PG&E Letter DCL-15-095

Response to NRC Request for Additional Information Regarding Recommendation 2.1  
of the Near-Term Task Force Seismic Hazard and Screening Report

## Response to NRC Request for Additional Information Regarding Seismic Hazard and Screening Report

Figure 2-1: Potential for nonlinear amplification for PGA. The black curve is the mean amplification. The red, blue, and green curves are for the central, upper, and lower VS profiles, respectively.

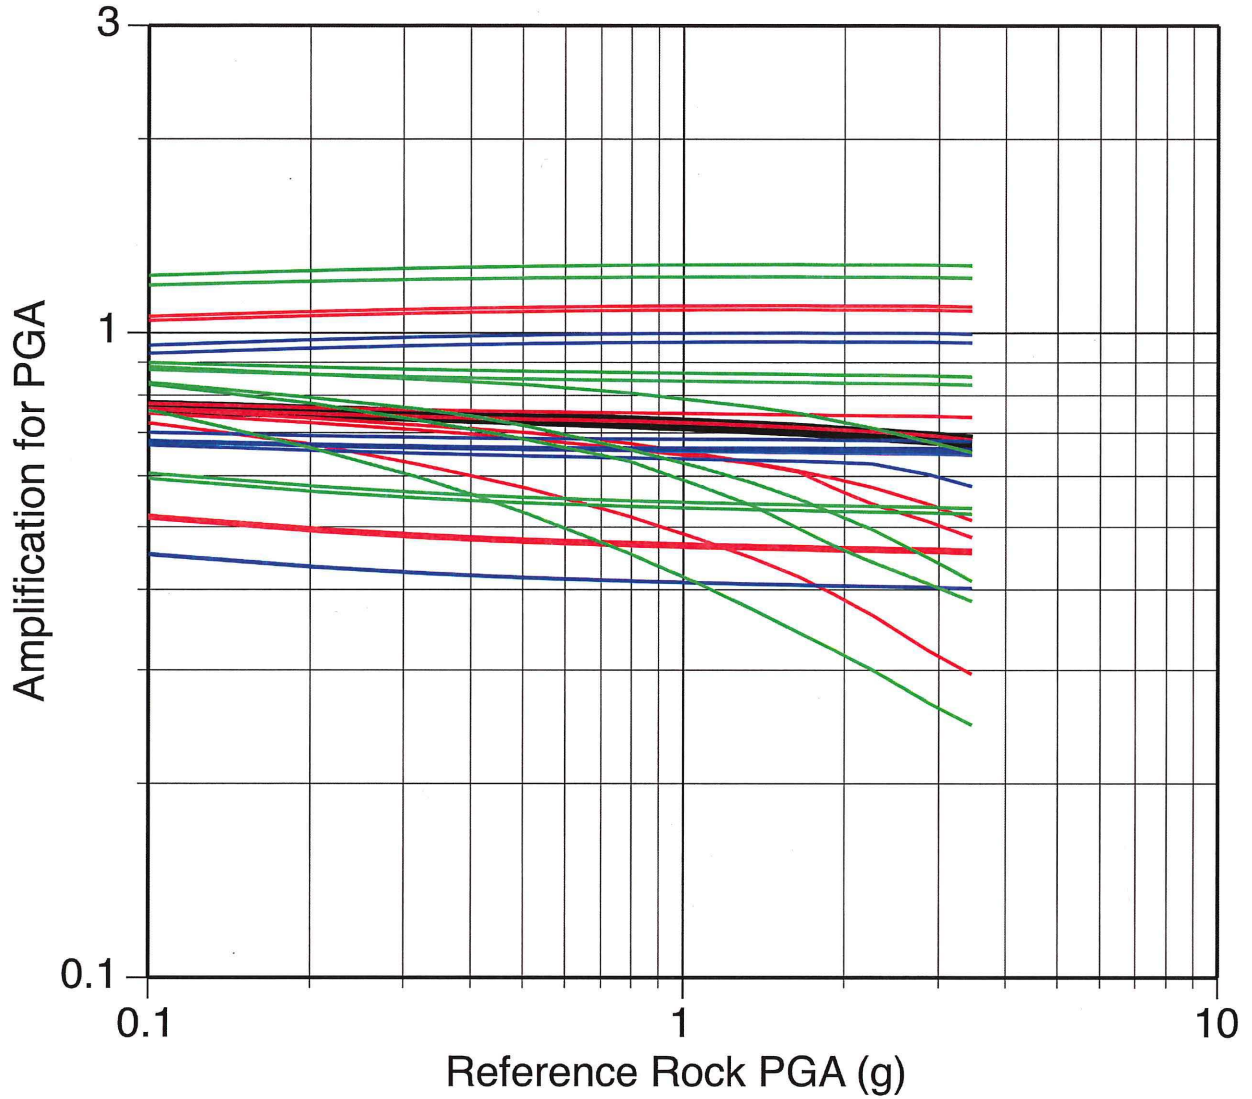
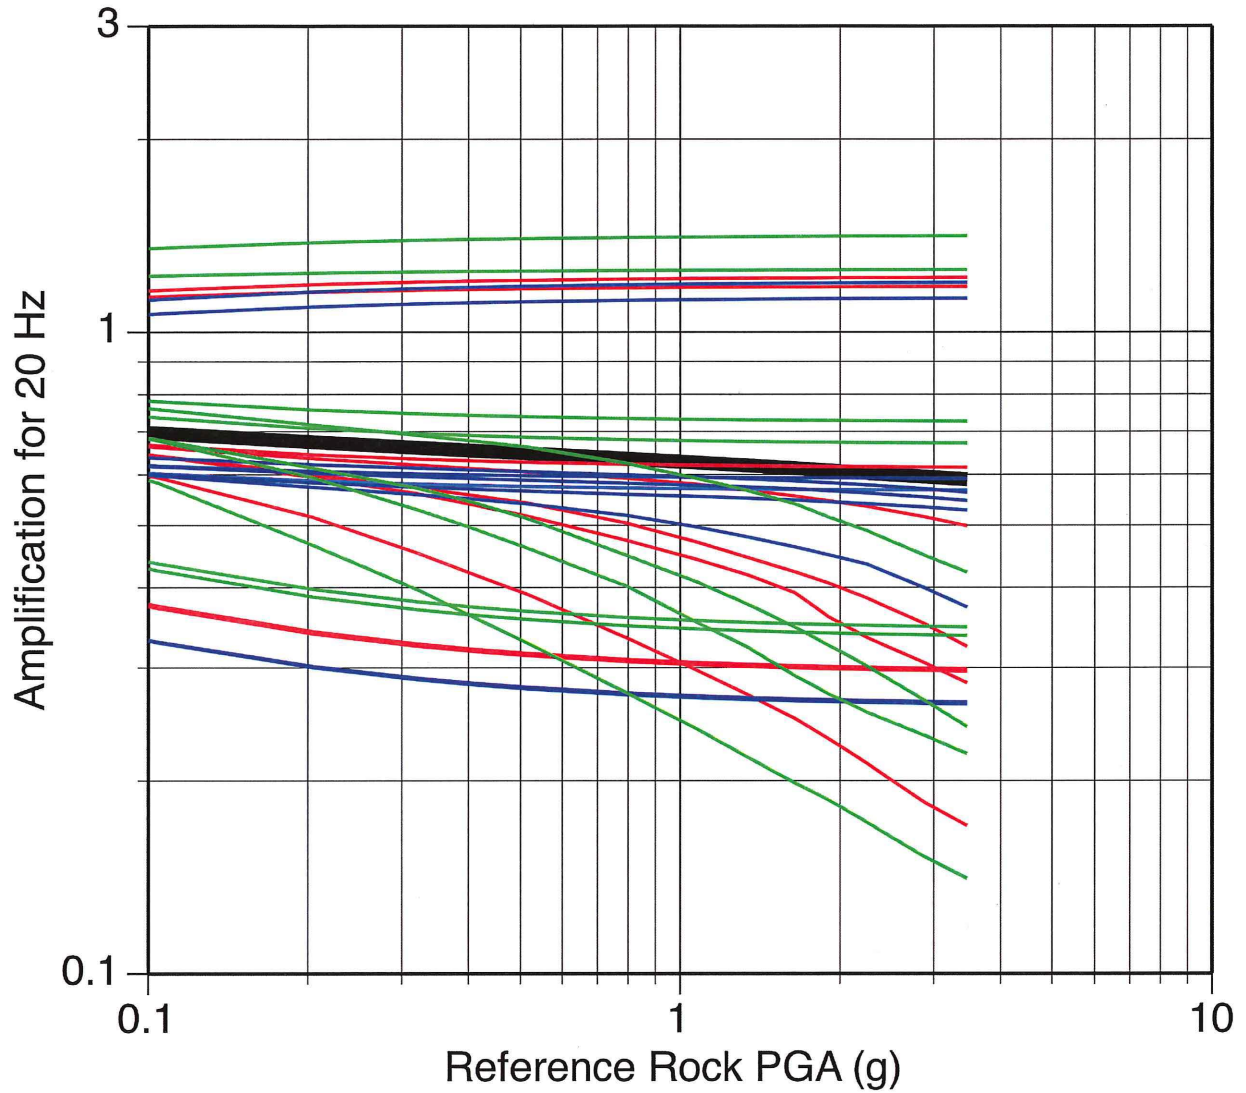
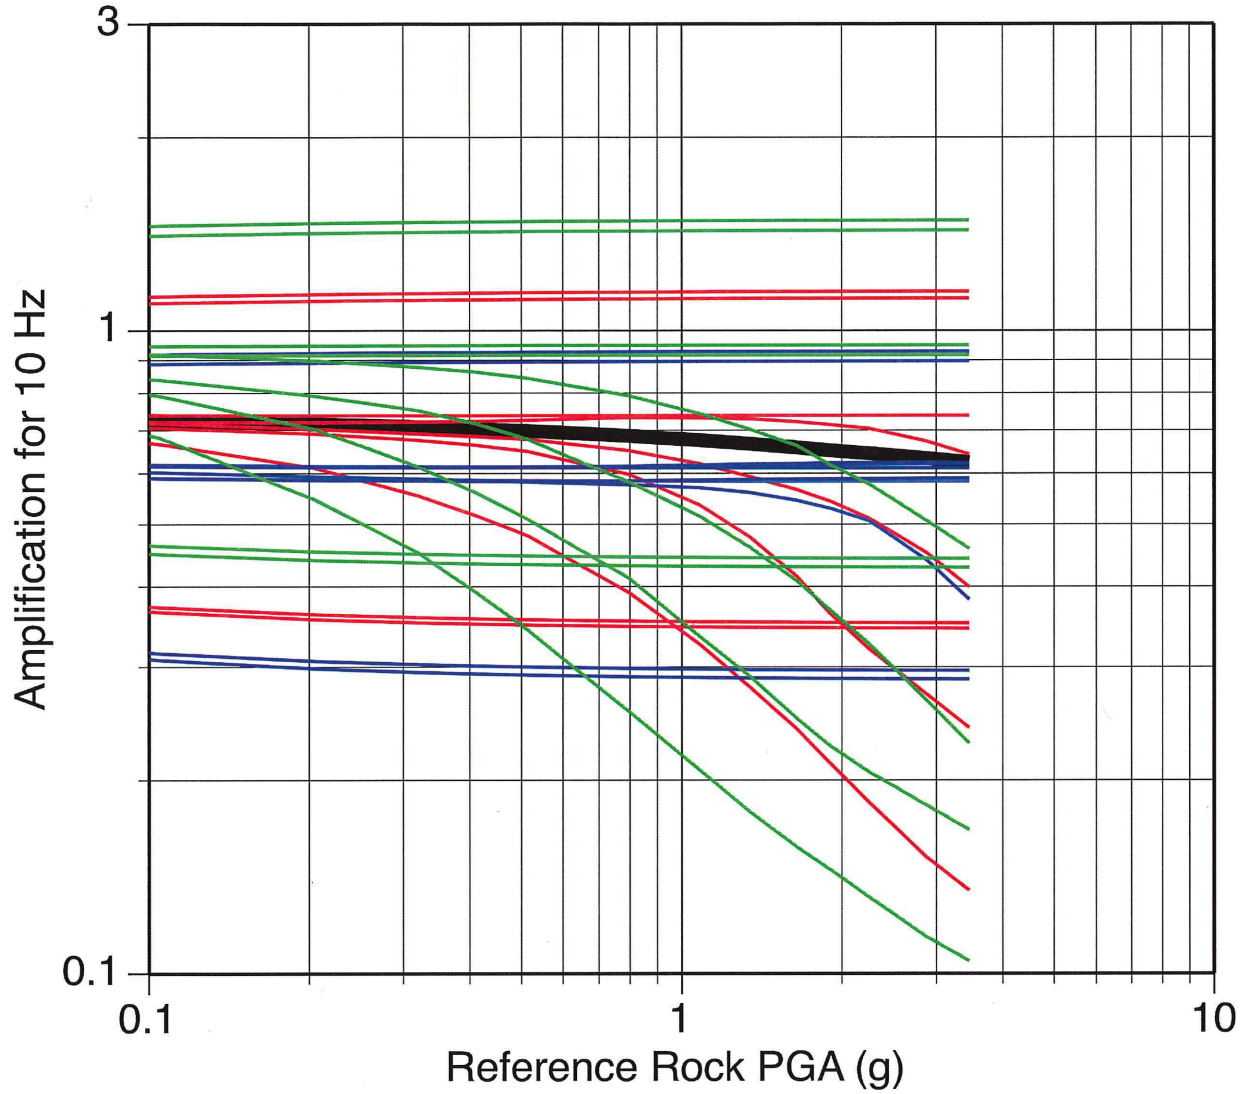
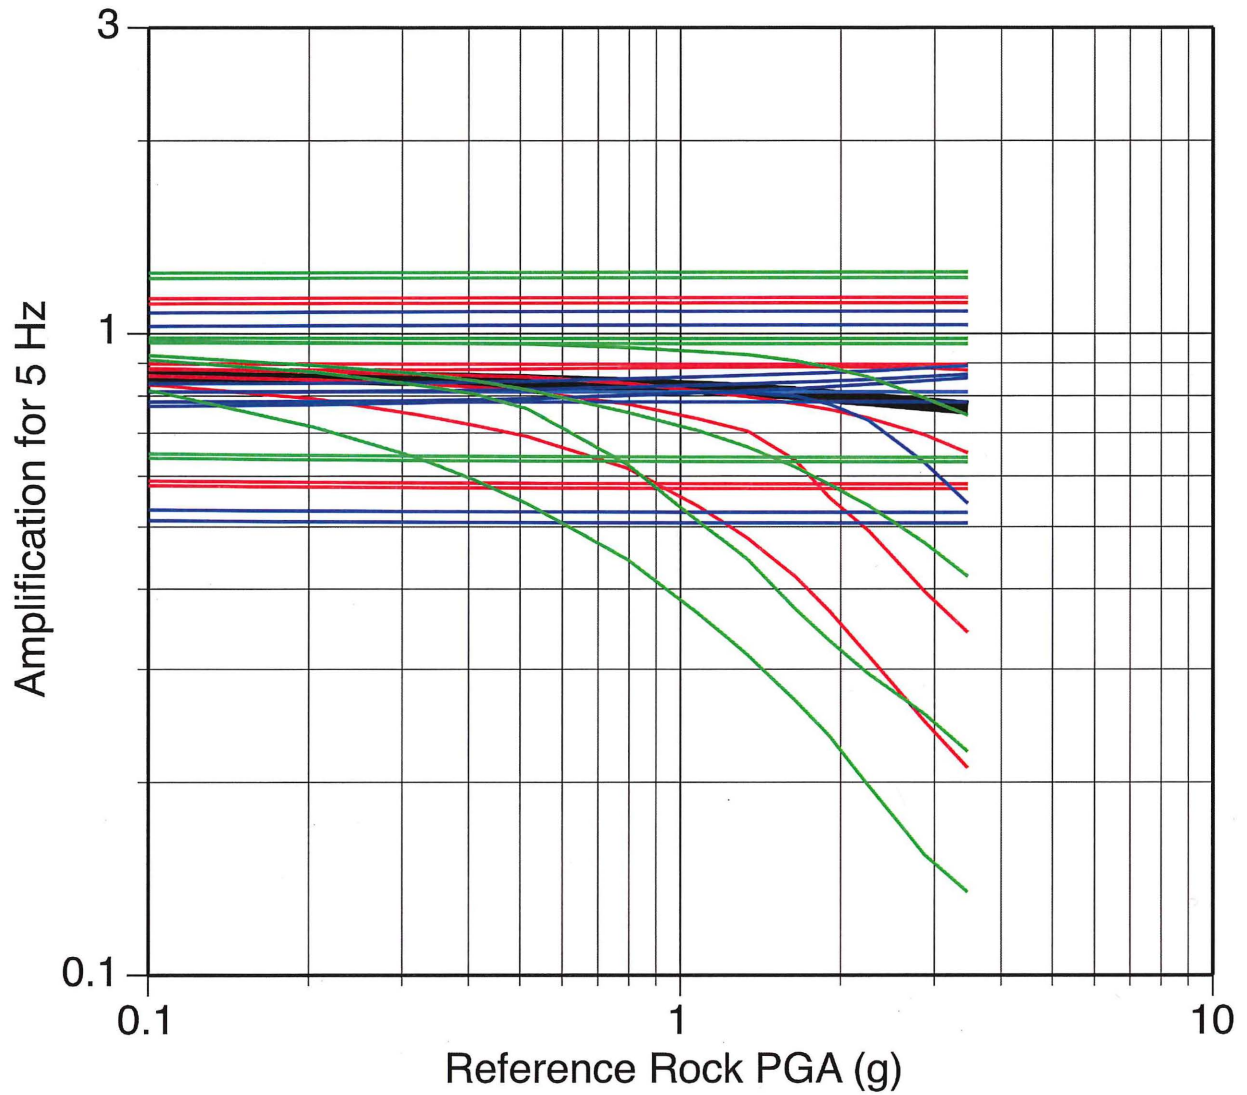
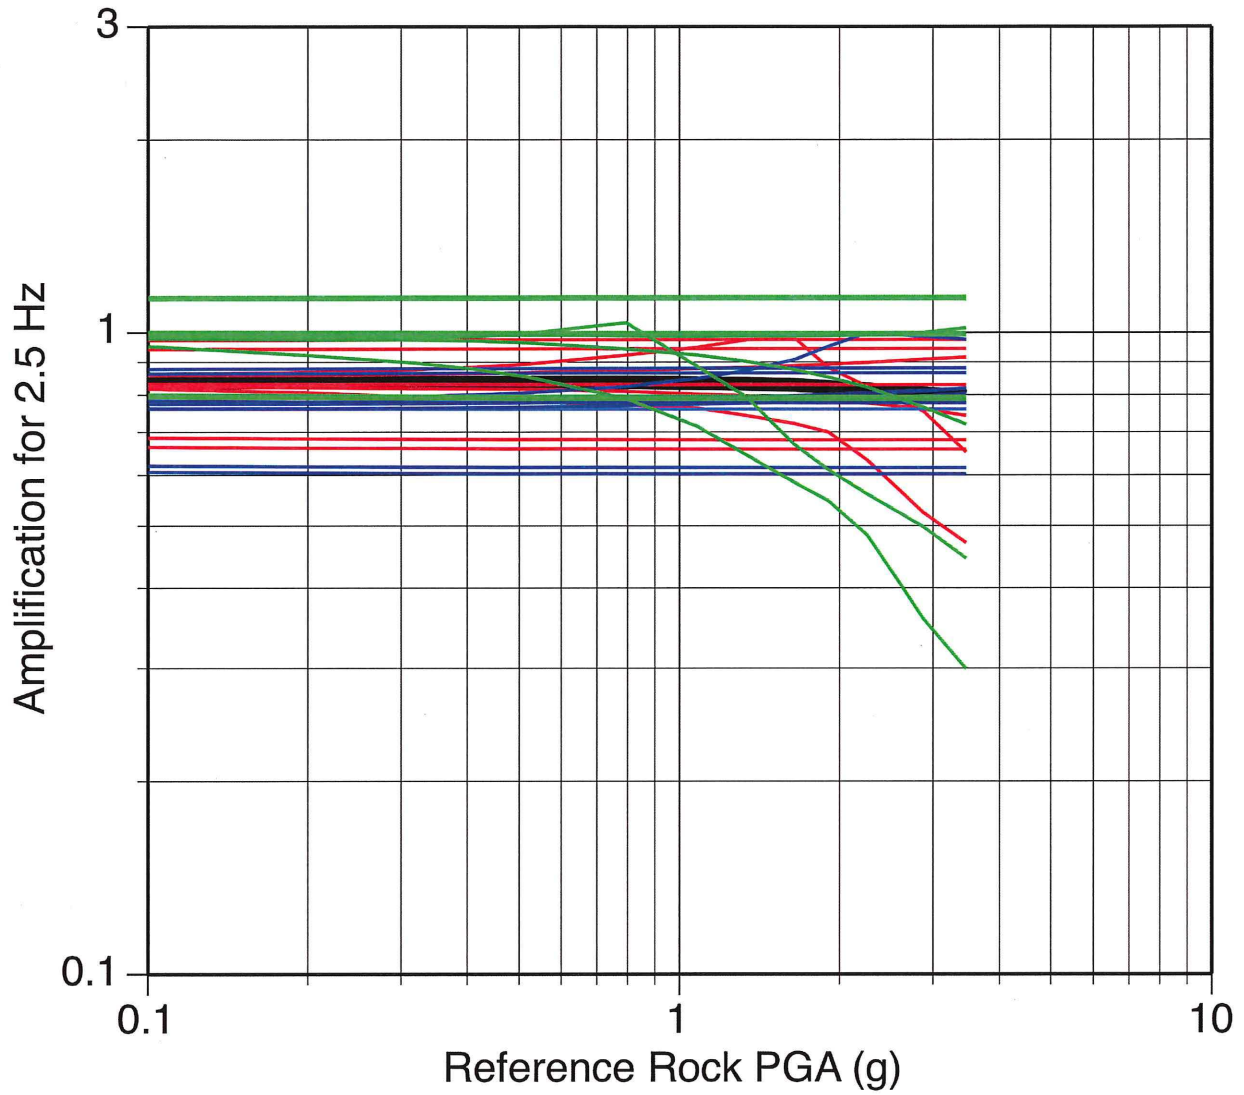
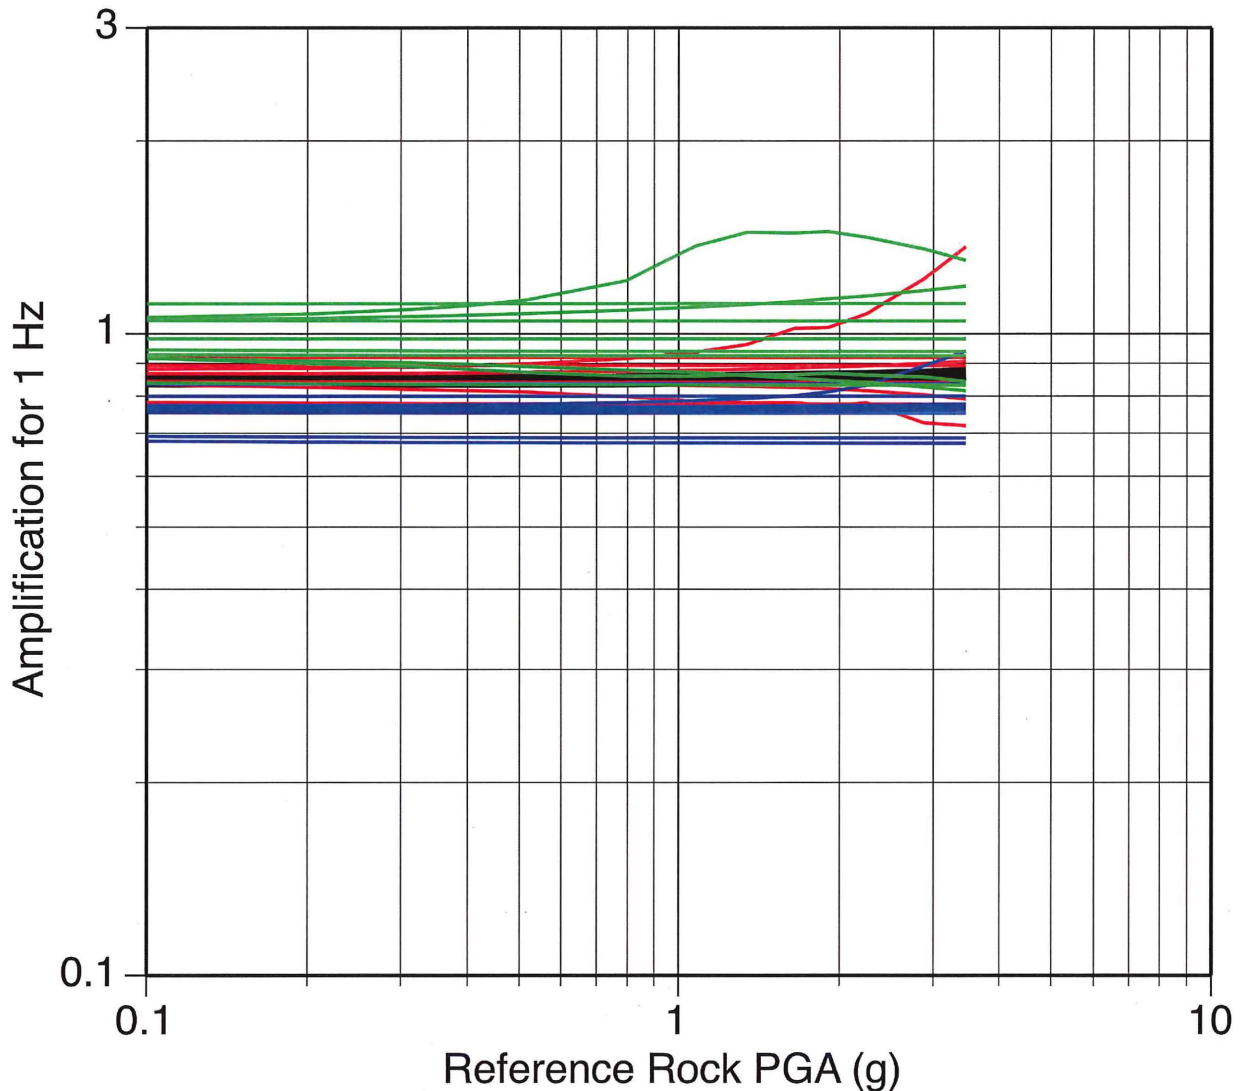
Please provide the potential for nonlinear behavior at the strain levels produced by the scenario earthquakes of interest

The potential nonlinear behavior of the rock is evaluated using equivalent linear site response (Reference 4). The resulting amplification is shown below as a function of the PSA for the reference rock condition ( $VS_{30} = 760$  m/s with linear site response) for PGA and 5 spectral frequencies (1 Hz, 2.5 Hz, 5 Hz, 10 Hz, and 20 Hz) in Figures 2-1 to 2-6. The range of the amplification for the 30 alternative models of the VS,  $\kappa$ , and material properties is shown for each frequency. For reference, the  $1E-4$  hazard for the reference rock case corresponds to a peak acceleration of about 1 g.
